AMENDMENT OF SOLICITATION/MODIFICATION OF CONTRACT

2. AMENDMENT/MODIFICATION NUMBER
00073. EFFECTIVE DATE
04-05-2021

The purpose of this amendment is to provide the following:

1. A copy VA Addendum 2 combined document as well as the Addendum 2 Attachments and Narrative Documents.
2. A copy of 23 07 11 HVAC and Boiler Plant Insulation Document.
3. A copy of the Exterior Site Plan Dumpster Laydown Document.
4. A copy of the Minneapolis Mental Health Technical Questions Spreadsheet.
5. A copy of the Addendum 2 Revision Set 2
6. Technical question due date has been extended from April 6, 2021 to April 8, 2021 at 2:00 PM ET.

WON DOOR SUPPORT

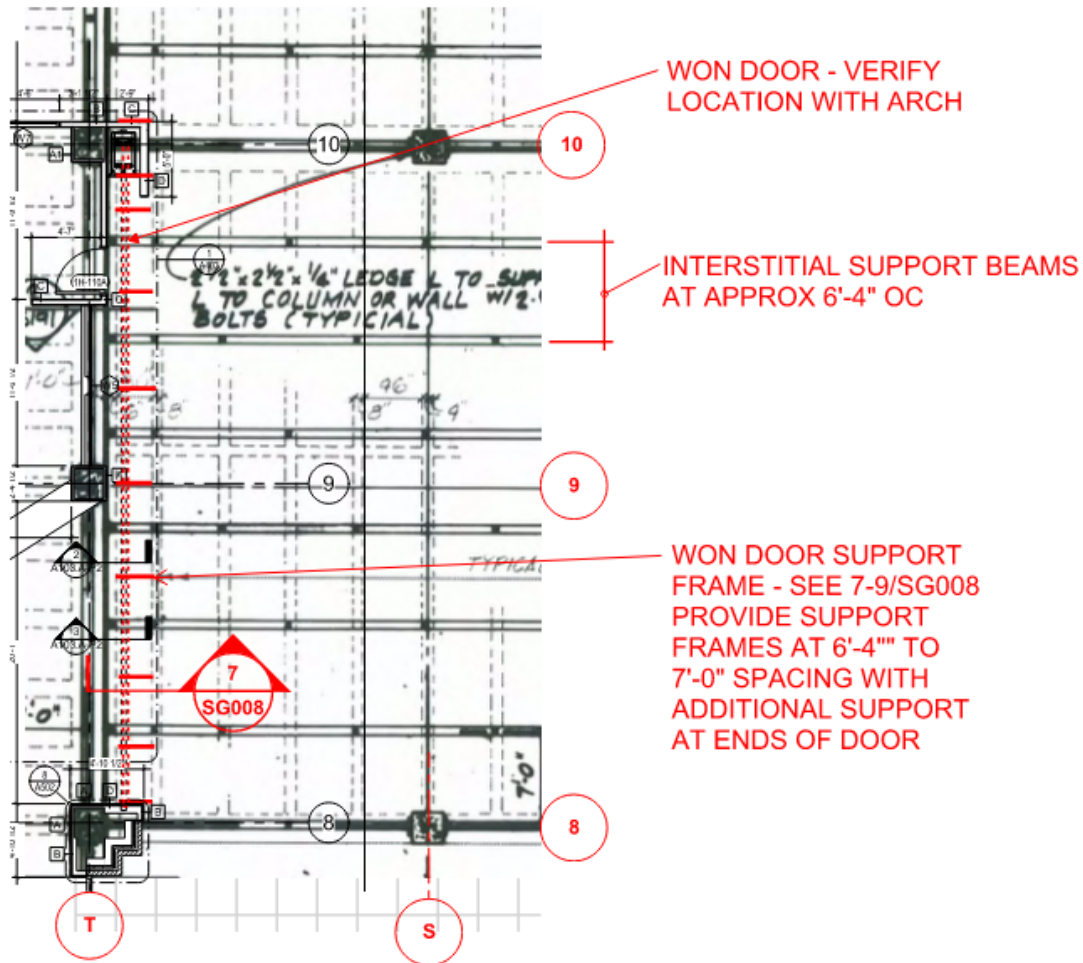
1. DETAILS 7,8,9: Details are for WON DOOR SUPPORT. Where details refer to plan, reference plan information below.

ACCORDION DOOR SUPPORT

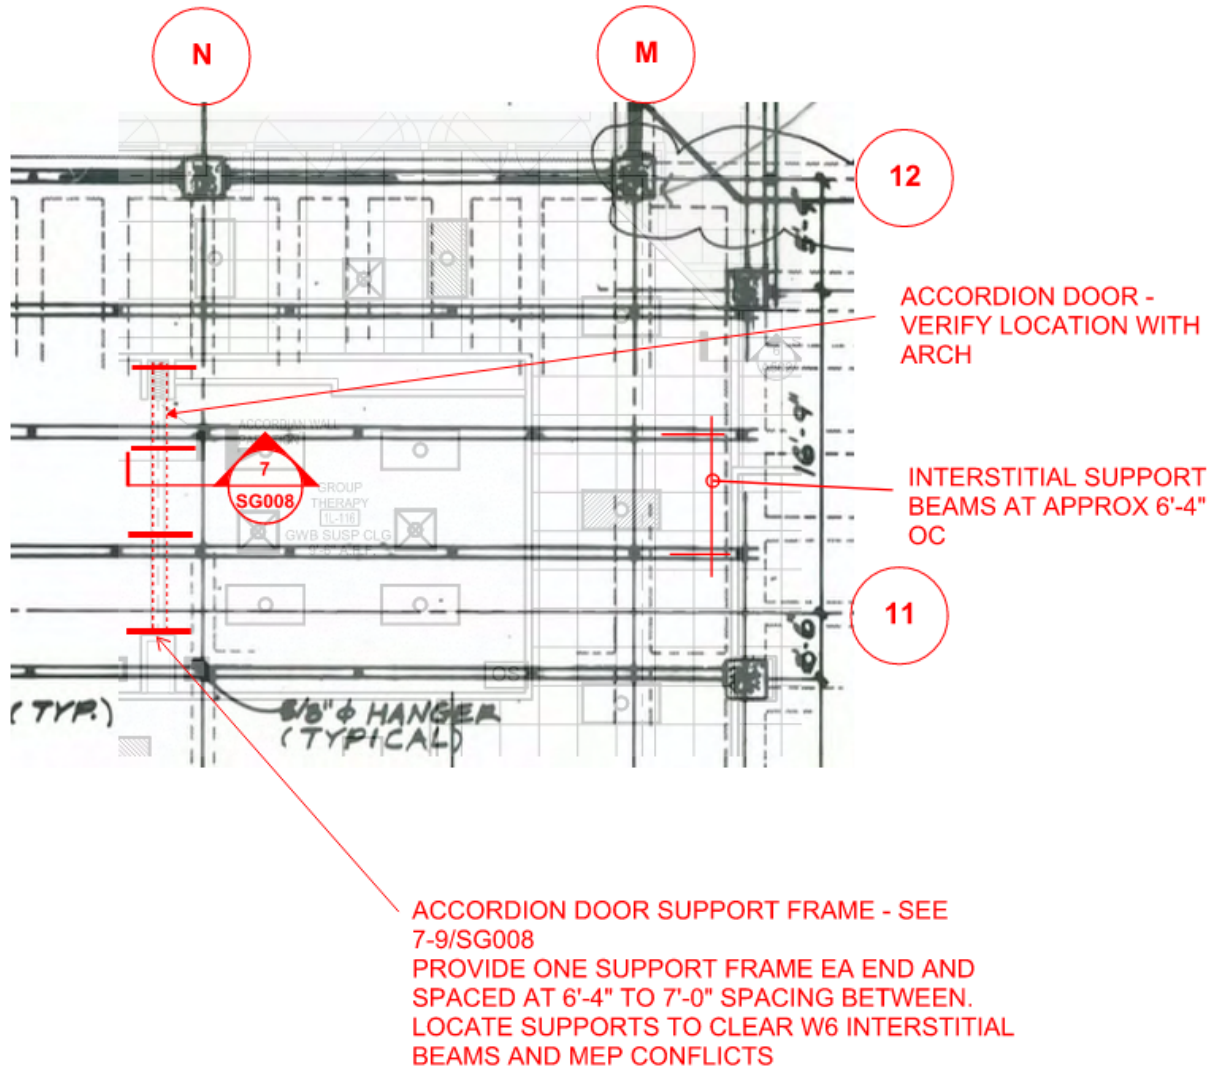
2. Refer to the plan information below for the structural support of the ACCORDIAN WALL PARTITION in phase 3, area L.

10 TYP INTERSTITIAL DECK PATCH (LESS THAN 4" DIA)
3" = 1'-0"

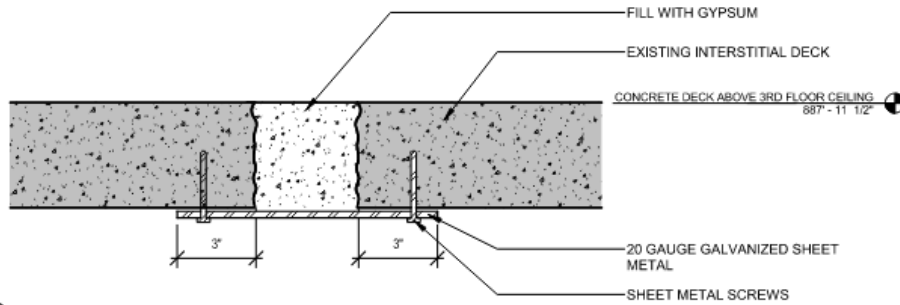
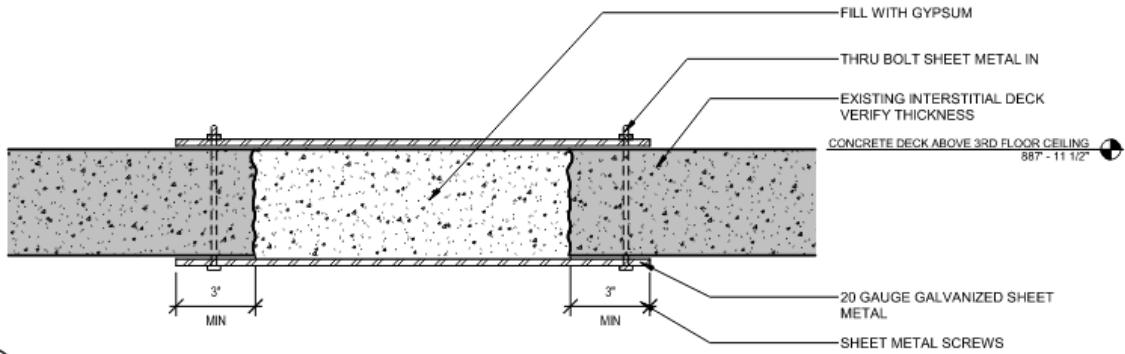
3. ADD the Details 10, 11 and INTERSTITIAL SPACE GENERAL NOTES provided below to this sheet.

INTERSTITIAL SPACE GENERAL NOTES	
1.	VERIFY EXTENT OF EXISTING PENETRATIONS THROUGH THE INTERSTITIAL BARRIER ONCE DEMOLITION OF MECHANICAL DUCTING, PLUMBING AND ELECTRICAL SYSTEM IS COMPLETE
2.	VERIFY PLANNED REUSE OF EXISTING PENETRATIONS BY MECHANICAL AND ELECTRICAL CONTRACTORS TO ESTABLISH EXTENT OF ABANDONED PENETRATIONS. REVIEW SURVEY / INVENTORY LIST WITH MECHANICAL AND ELECTRICAL CONTRACTORS.
3.	PATCH ALL ABANDONED PENETRATIONS THROUGH THE INTERSTITIAL BARRIER THAT ARE GREATER THAN FOUR SQUARE INCHES AS INDICATED ON DETAIL 11
4.	PATCH ALL ABANDONED PENETRATIONS THROUGH THE INTERSTITIAL BARRIER THAT ARE LESS THAN FOUR SQUARE INCHES AS INDICATED ON DETAIL 10
5.	VERIFY / COORDINATE SIZE AND LOCATIONS OF ADDITIONAL REQUIRED OPENINGS / PENETRATIONS IN THE INTERSTITIAL BARRIER. SAWCUT AND REMOVE BARRIER MATERIAL AT THESE LOCATIONS AS REQUIRED TO ACCOMMODATE DETAIL

FLOOR DRAIN IN EXISTING SLAB

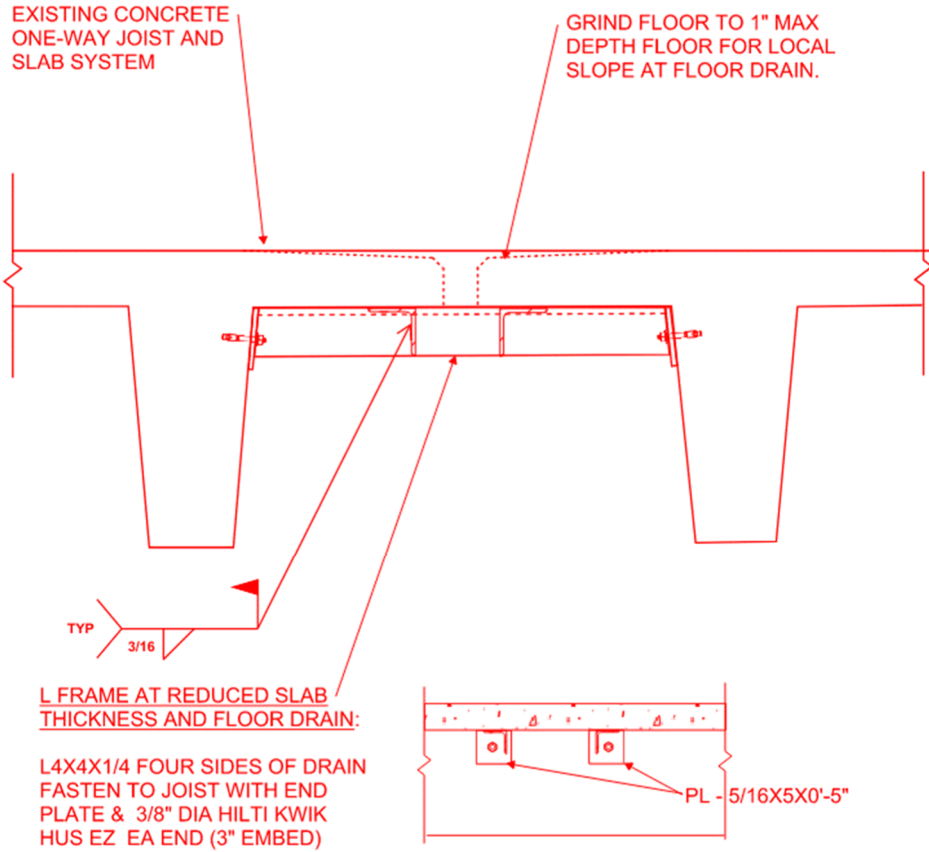
4. ADD to sheet detail 13, shown below: Shower Floor Recess for use @ STAFF LKR/TLT Rm 1H-105.

TOILET PARTITION SUPPORT

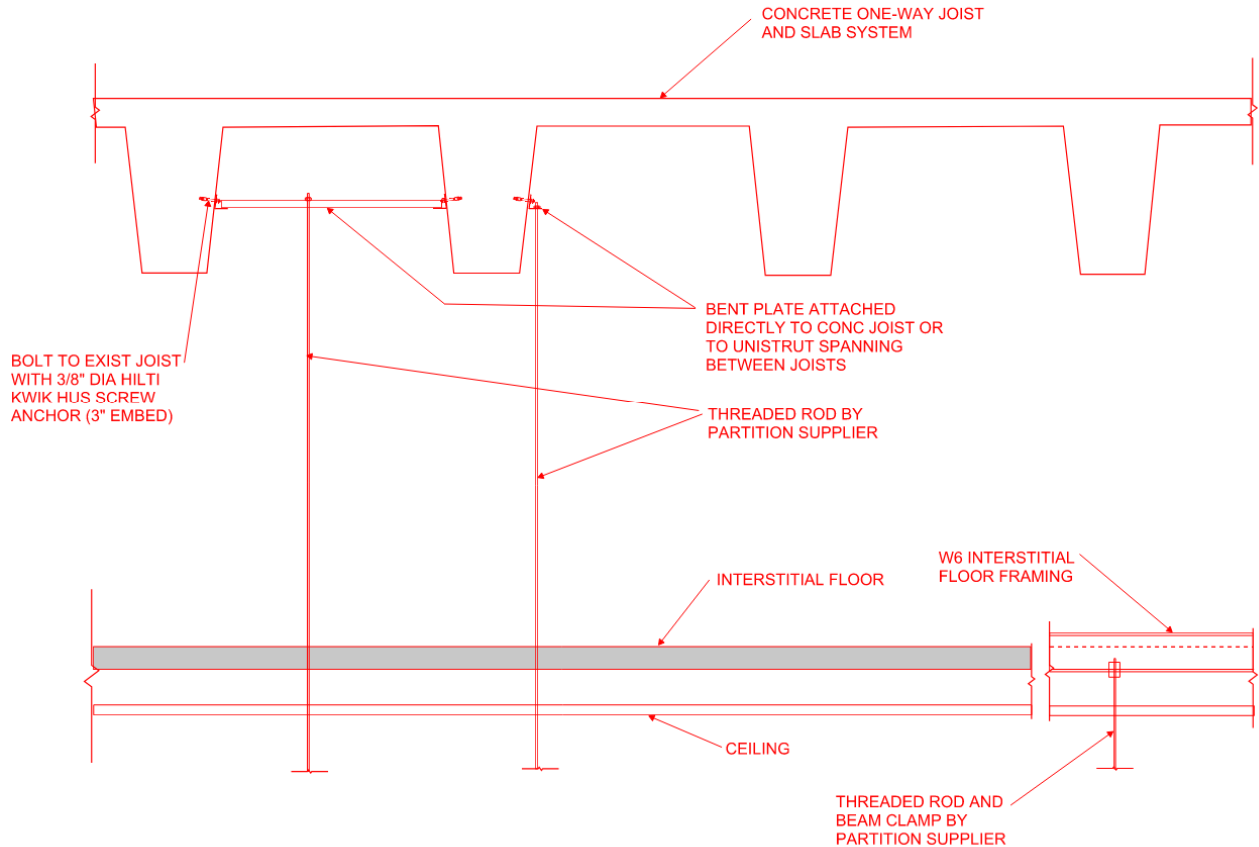
5. ADD to sheet detail 14, shown below: Toilet Partition Support @ STAFF LKR/TLT Rm 1H-105.
